HARRIS QUARRY USE PERMIT AND RECLAMATION PLAN FINAL ENVIRONMENTAL IMPACT REPORT

STATE CLEARINGHOUSE NO. 2006112087

February 2012

COMMENTS AND RESPONSES ON THE RDEIR

Figure 1: Willits, CA Wind Rose – Daytime Hours (6 a.m. – 6 p.m.)

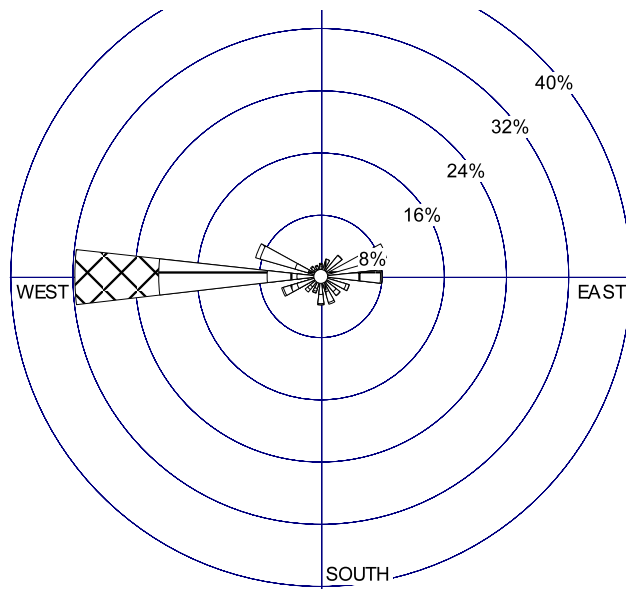
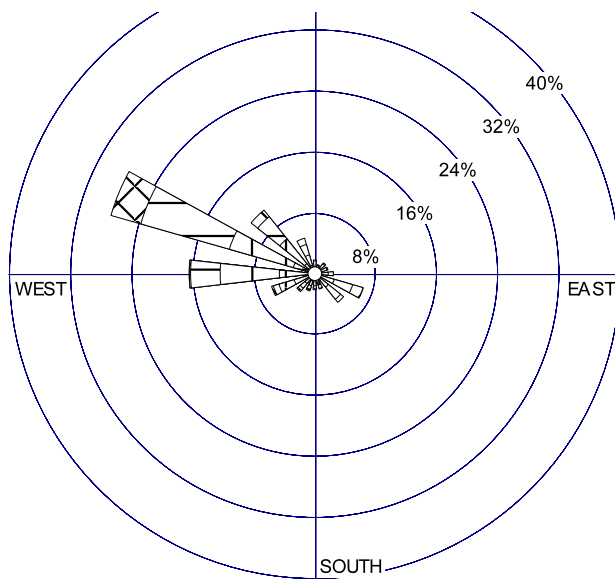
typically distributed at a particular location. Figures 1 and 2 below show wind roses for the 2004 Willits meteorological data and the MM5 derived surface meteorological data for the Harris Quarry site, respectively, during the daytime hours 6 a.m. to 6 p.m. This time period is representative of the conditions when project operations would occur and was also used in the dispersion modeling. The wind directions shown in the wind roses are for the direction that the wind is coming from.

To evaluate what effects the use of the Willits meteorological data may have on modeled concentrations in areas of sensitive receptors when compared to use of site specific project data, the MM5 derived Harris meteorological data was used as a surrogate for actual site specific measured data. This allows for reasonable conclusions to be drawn as to the appropriateness of the Willits data used in the RDEIR dispersion modeling and assess whether use of site specific monitoring would likely change the findings of the RDEIR.
